PLANNING, ZONING, & BUILDING DEPARTMENT
PZ&B Staff Combination Memorandum: Architectural Commission and Town Council

SUBJECT: ZON-24-0006 (ARC-24-0011) 1741 S OCEAN BLVD (COMBO)

MEETING: AUGUST 28, 2024, ARCOM
SEPTEMBER 11, 2024, TC

PROPOSED EAST ELEVATION

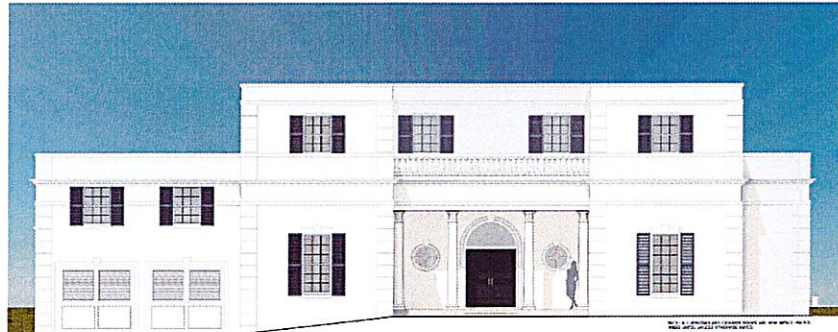
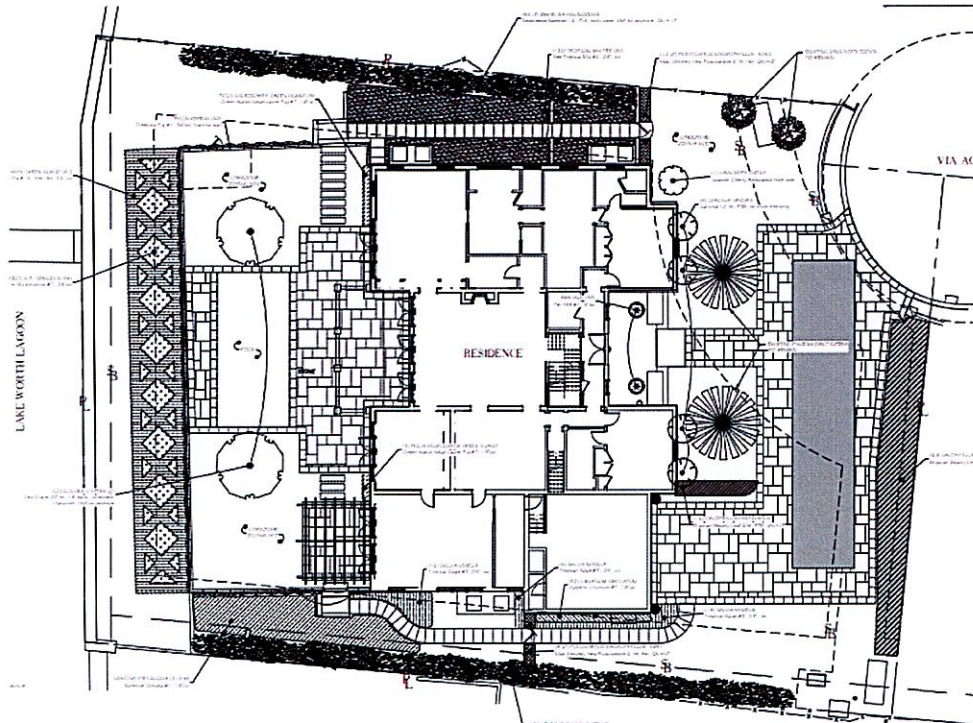
Since the last hearing the applicant has made window and door modifications, added some shutters, and redesigned the garage doors. On the front façade the enlarged transom arch and circular windows flanking the front door are also proposed changes from the last iteration.

The applicant is proposing modifications and additions to this existing Palm Beach Regency style single family residence. The property is located along the intracoastal waterway at the west terminus of Via Agape. The new addition centers the second floor and is in keeping with the existing architectural style. Window and door modifications will result in more classical proportions and the rear yard will see a reduction in pool size from 50' x 22' to 32' x 15'. The

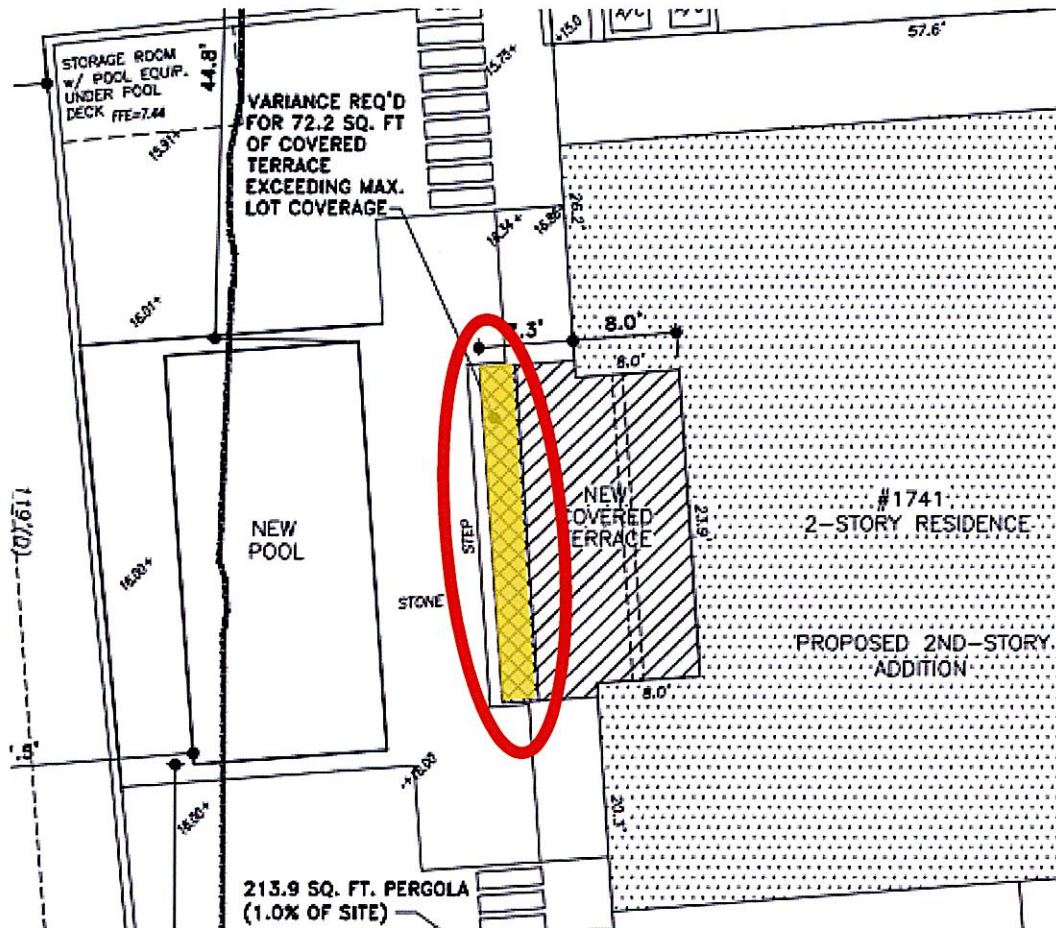
Variance #1 is being requested for the new terrace at the rear of the property to exceed the lot

coverage by approximately 72 SF, or .34%.
